ADDENDUM NO. 1 TO BID FORMS

**CORONA-NORCO UNIFIED SCHOOL DISTRICT
PURCHASING DEPARTMENT
Bid No. 2023/24-204**

CORONA FUNDAMENTAL INTERMEDIATE SCHOOL MPR MODERNIZATION

SHEET NO.:
A-423

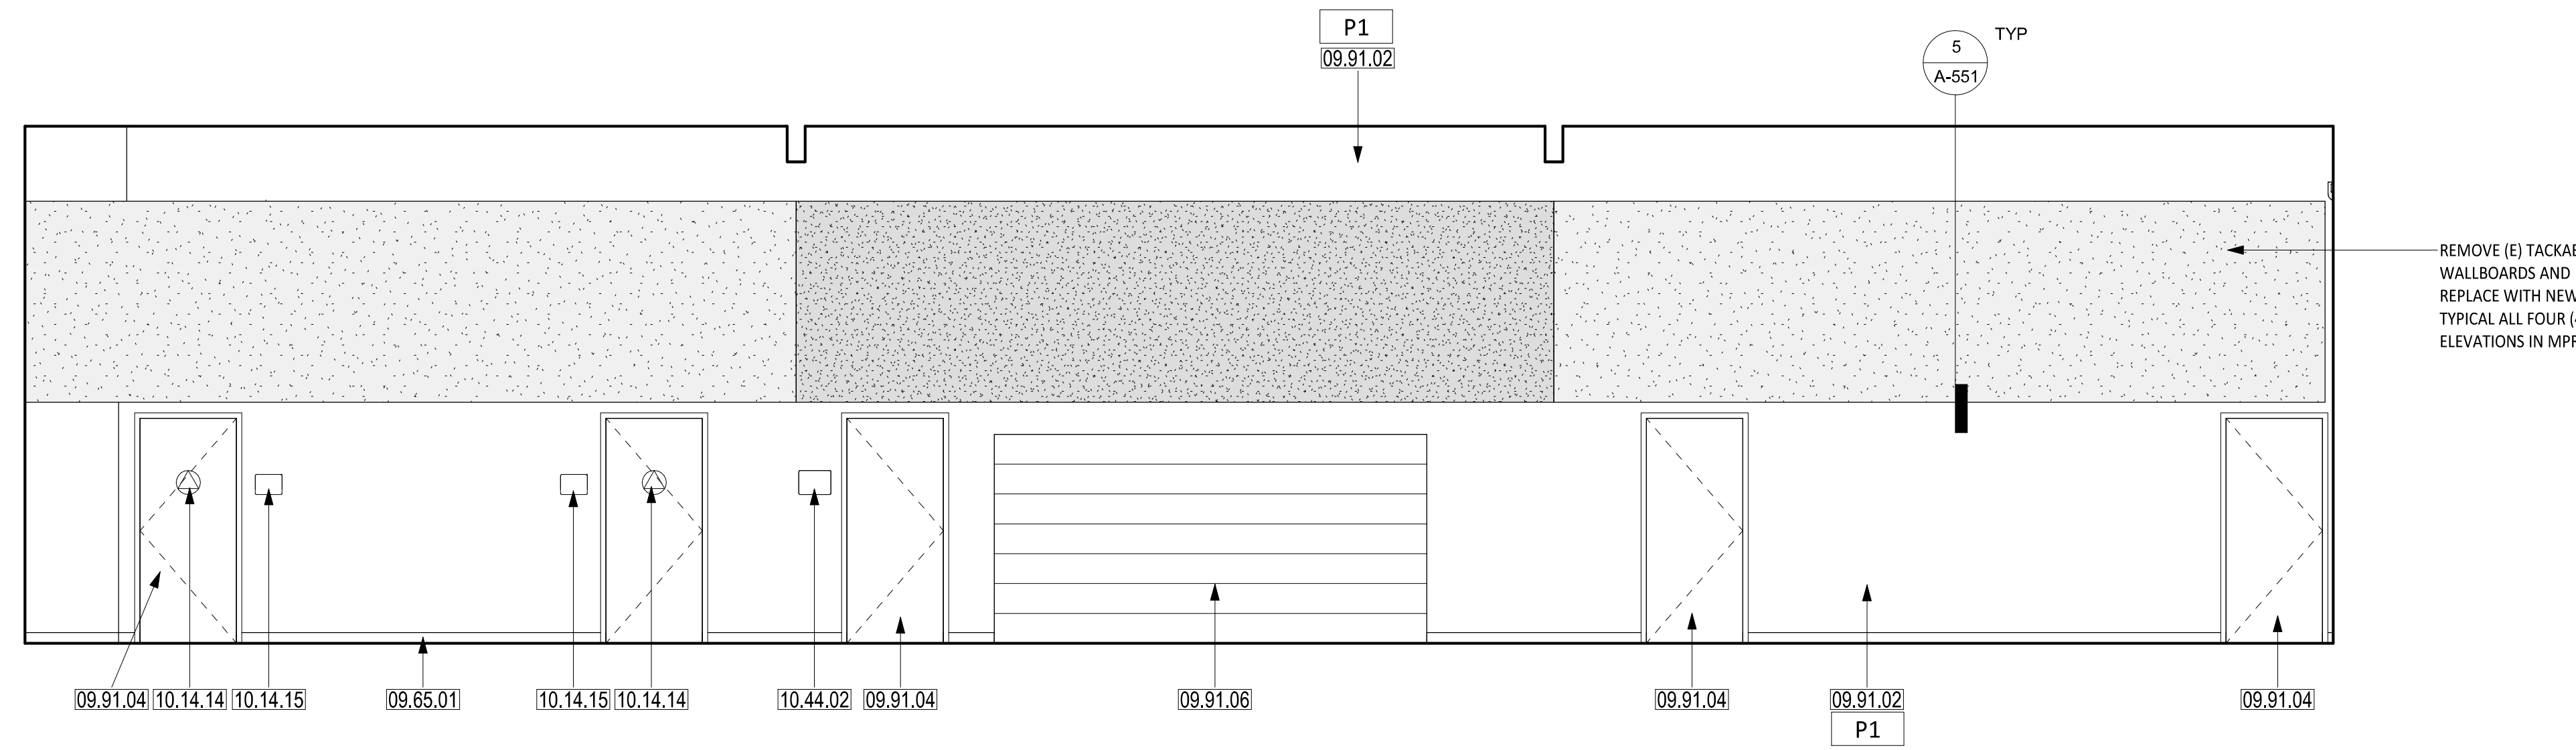
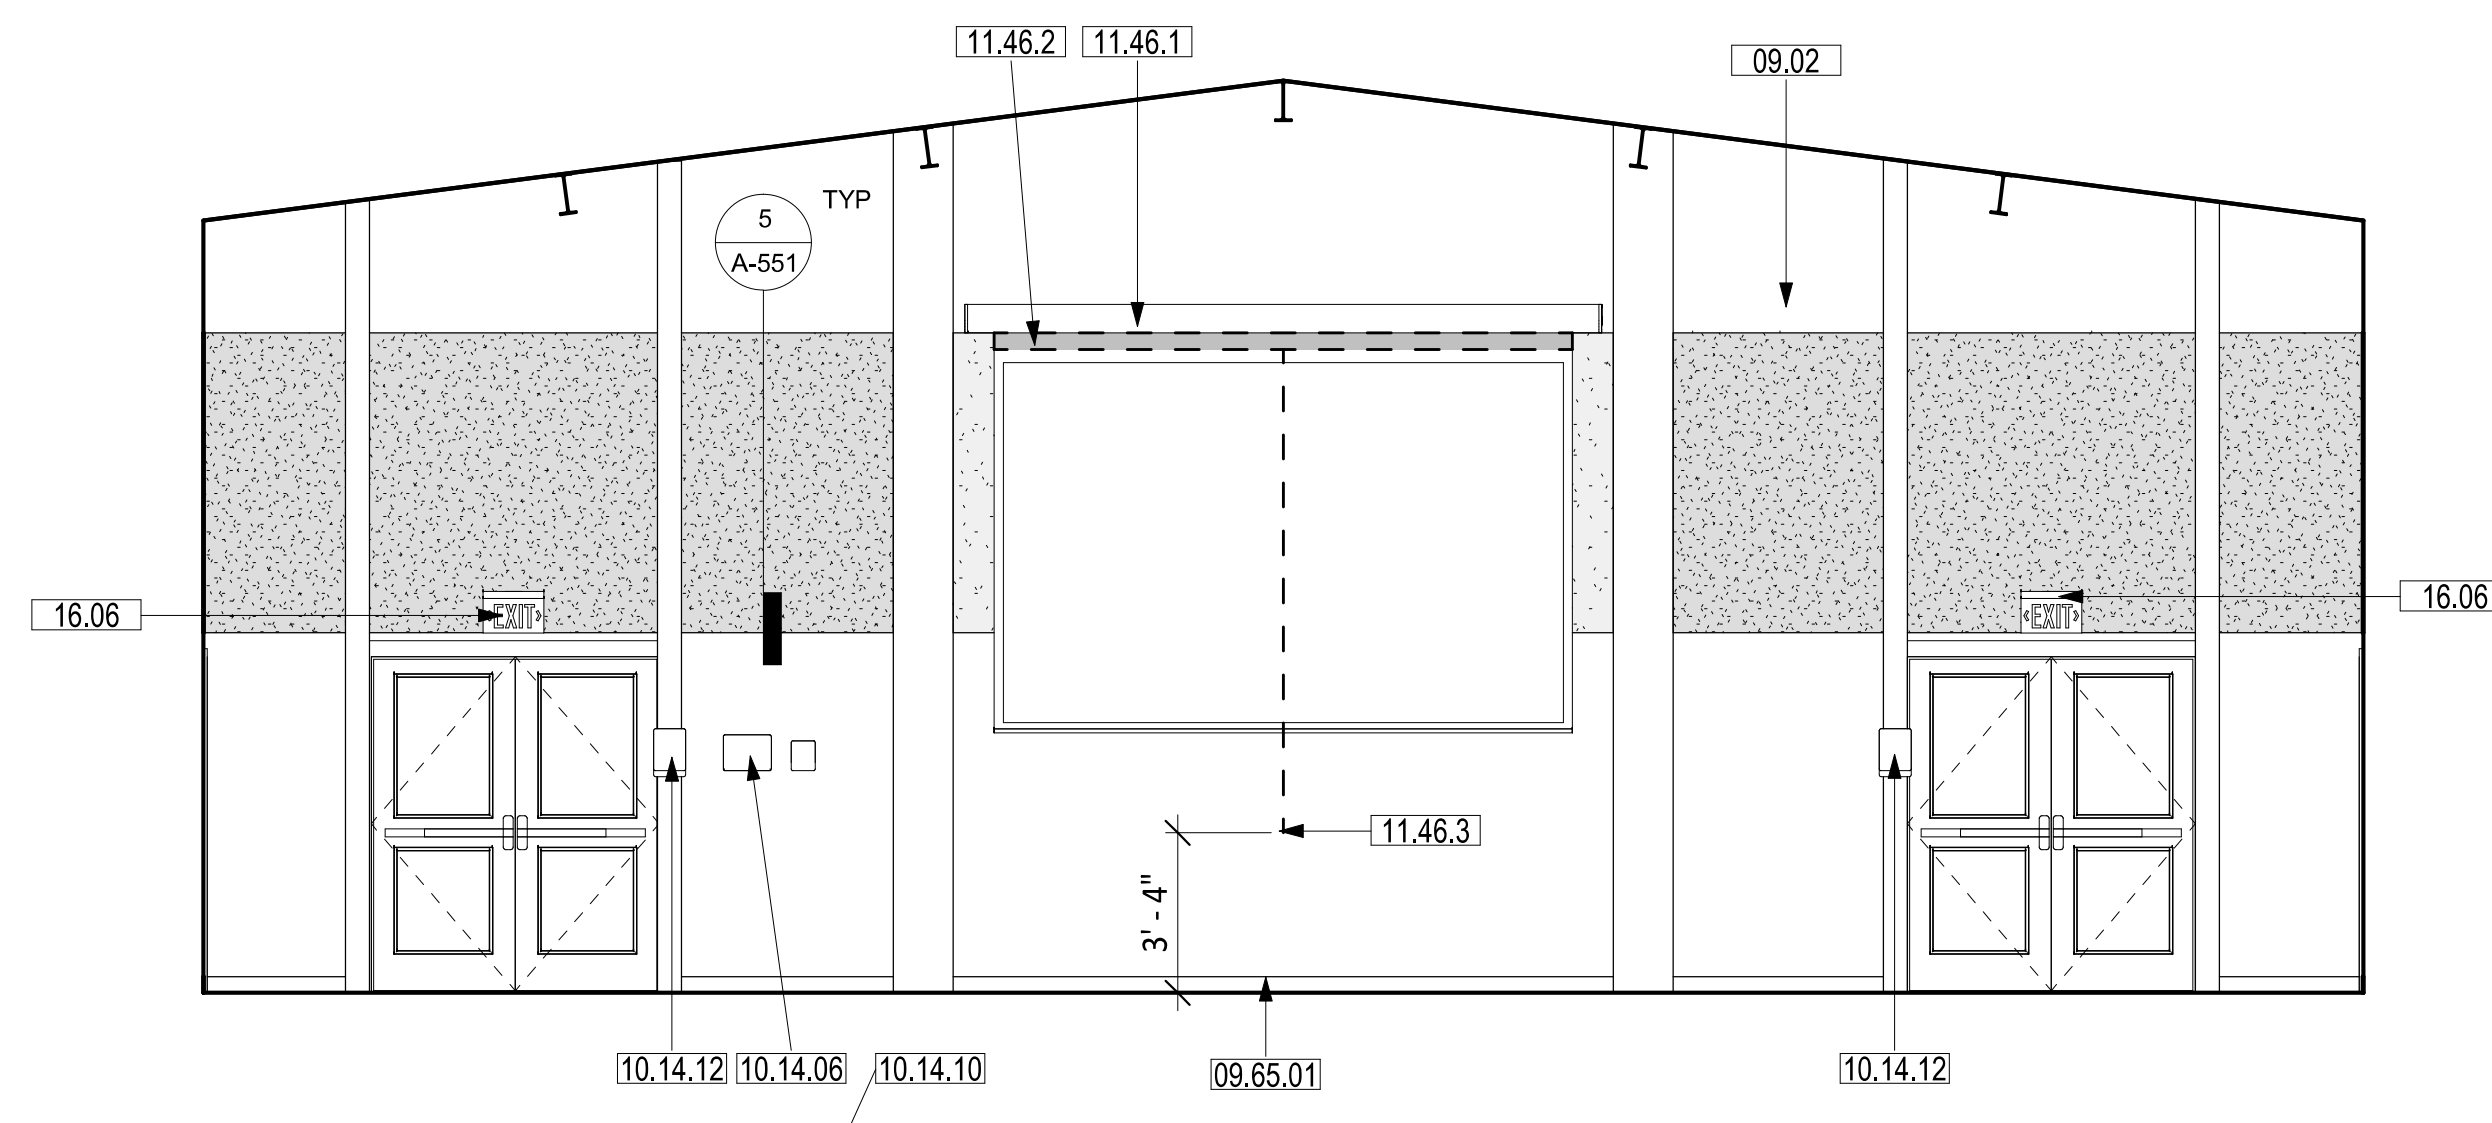
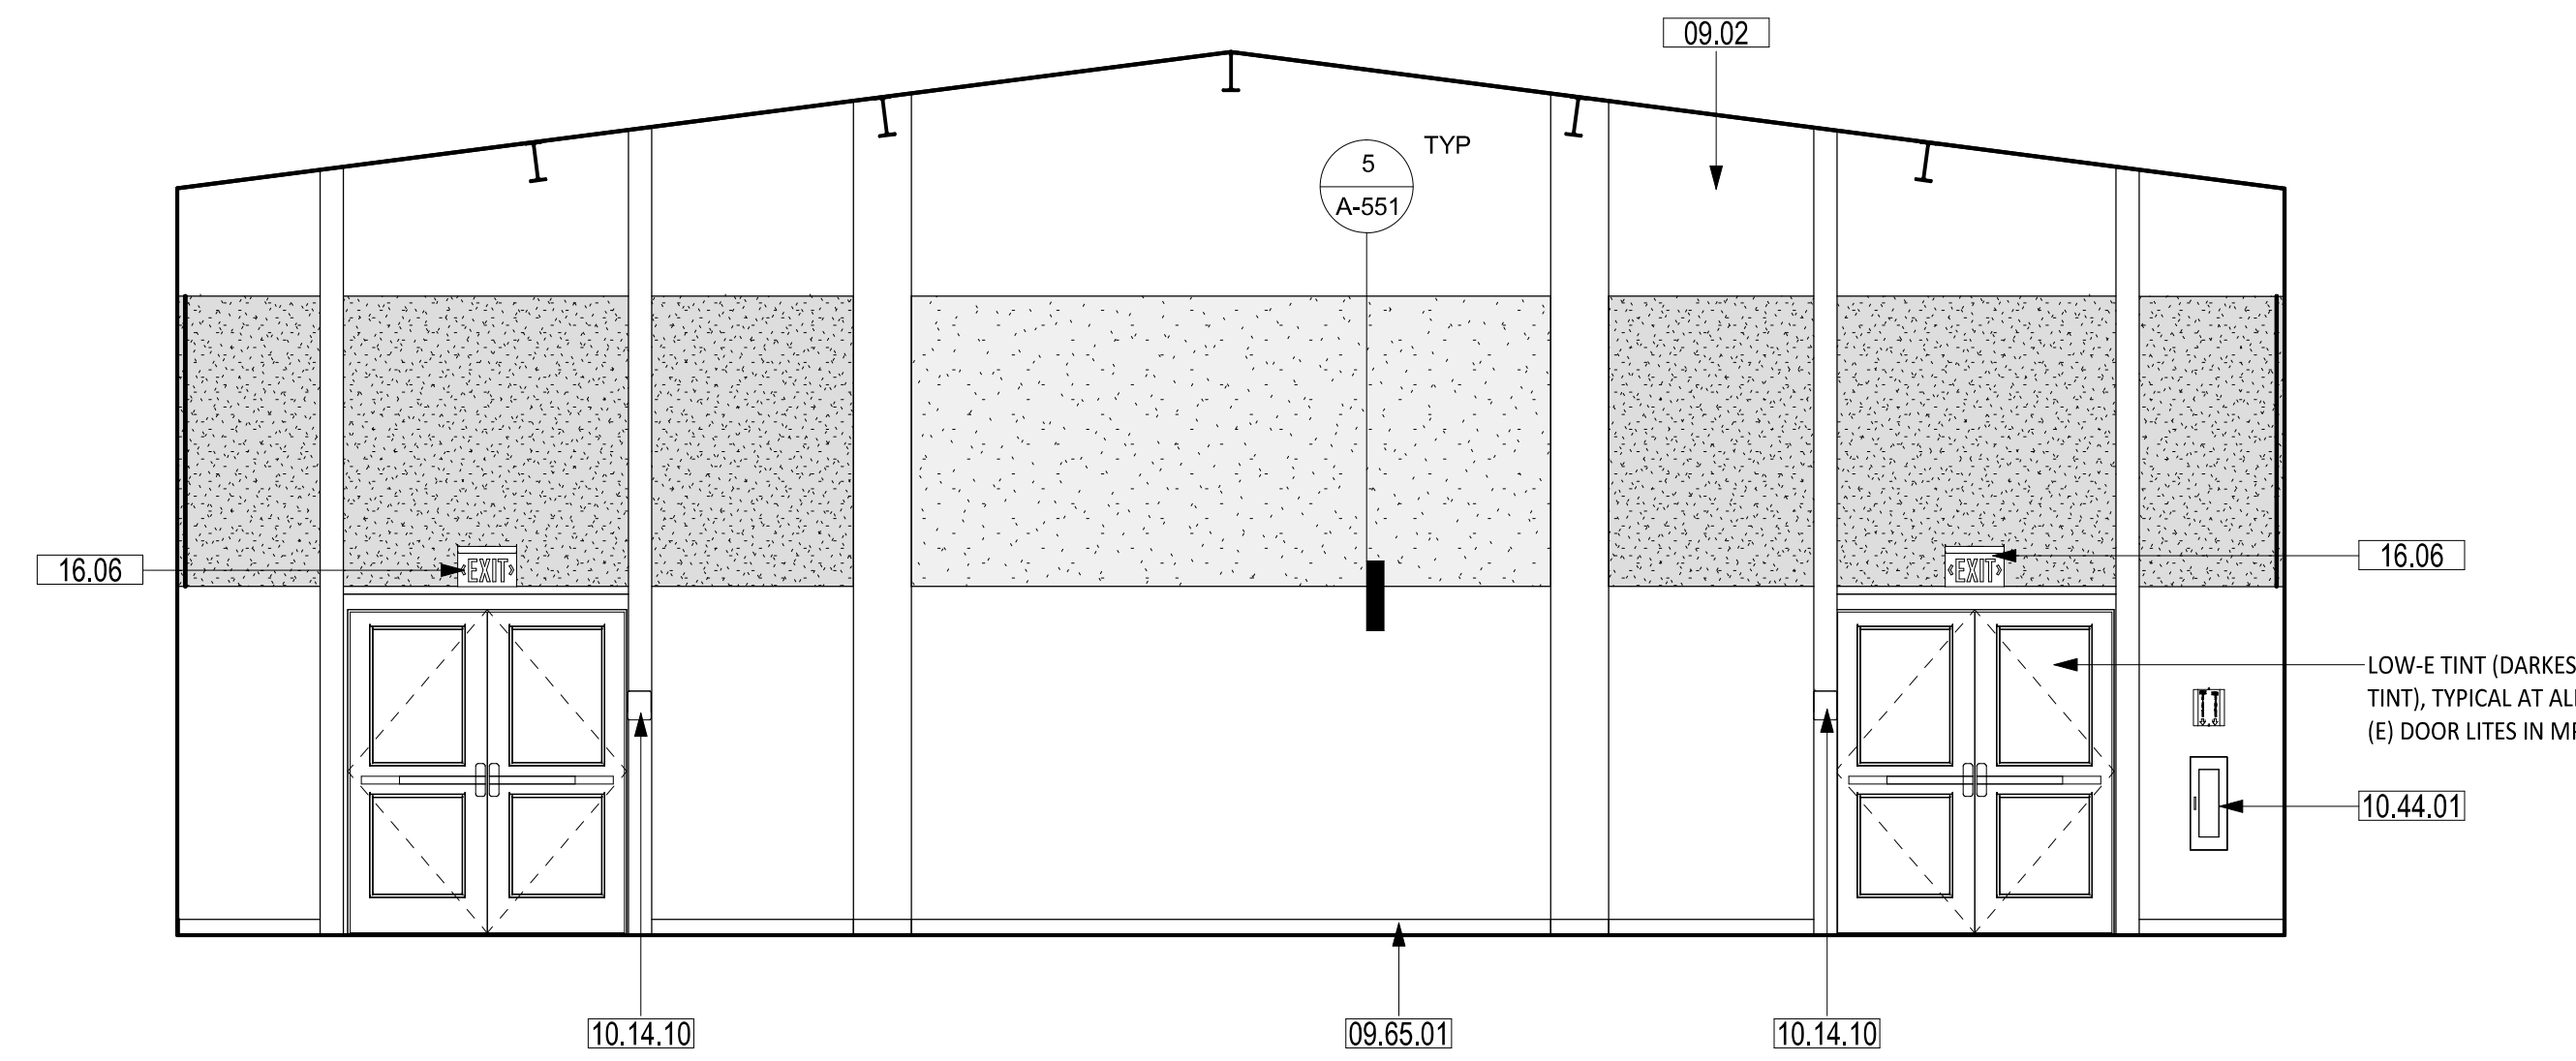
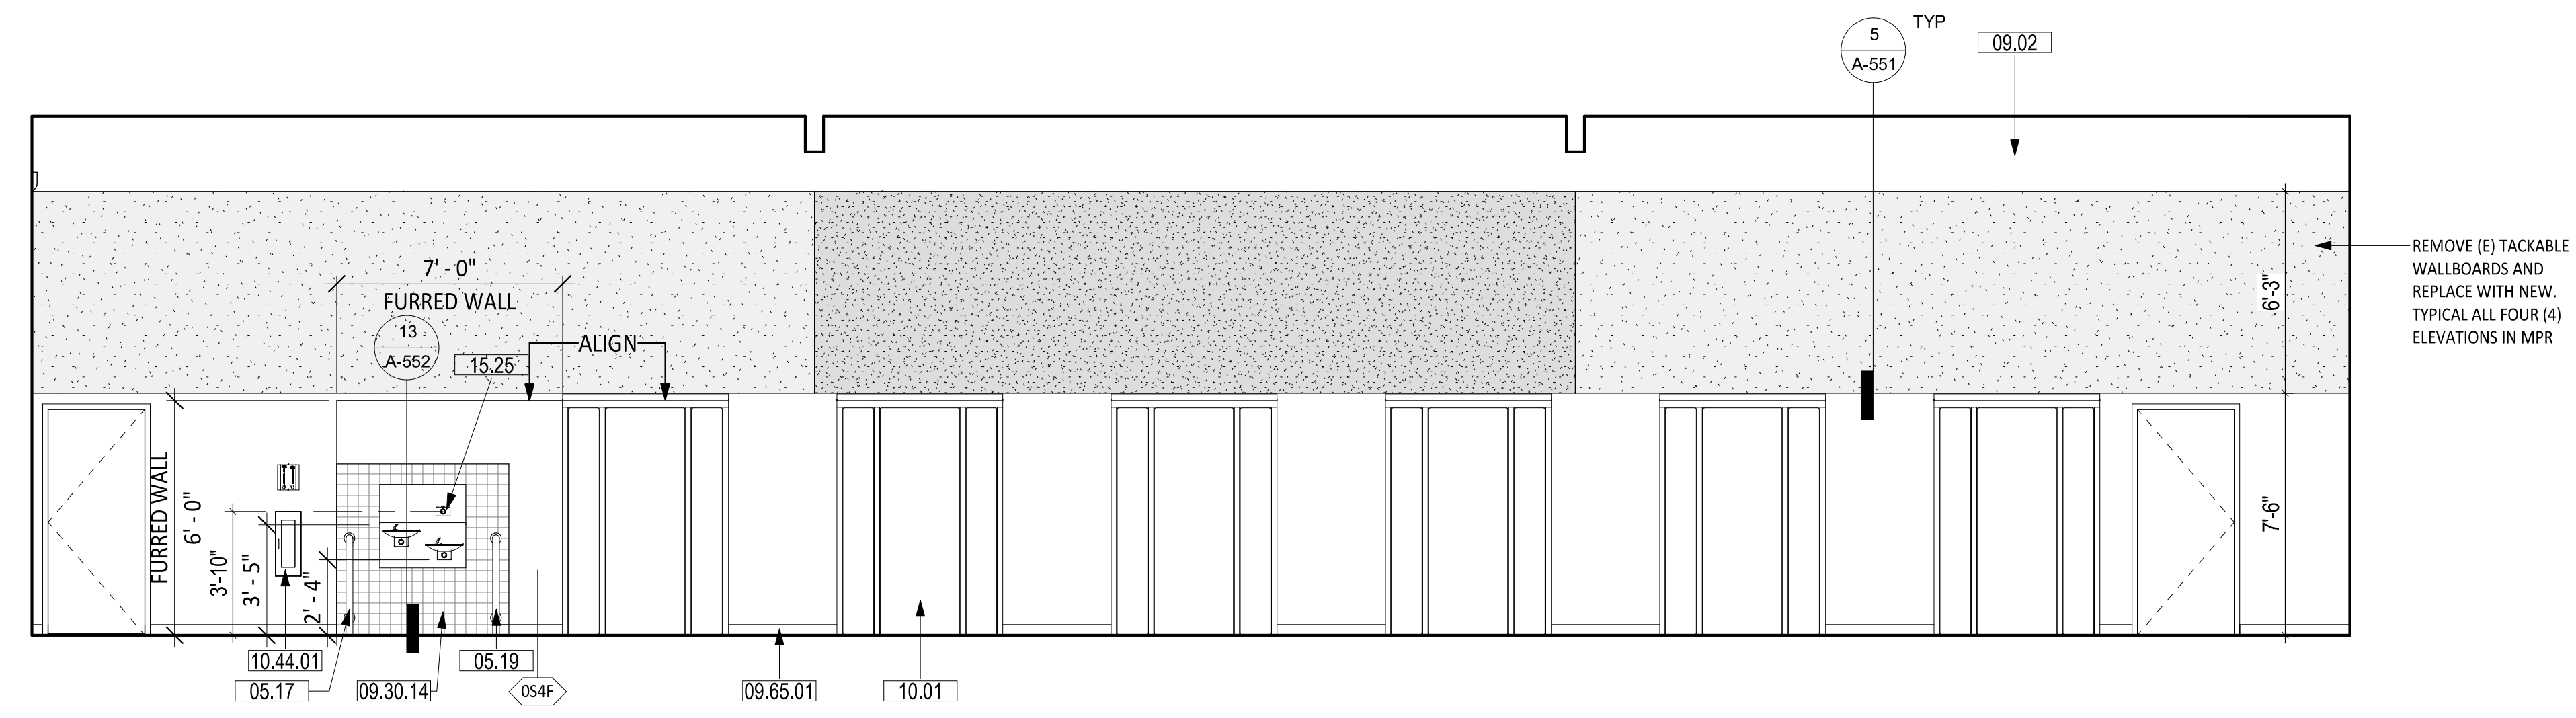
Item No. 1.09
Sheet A-423 - MPR - INTERIOR ELEVATIONS

- Keynote 95.65.01 revised
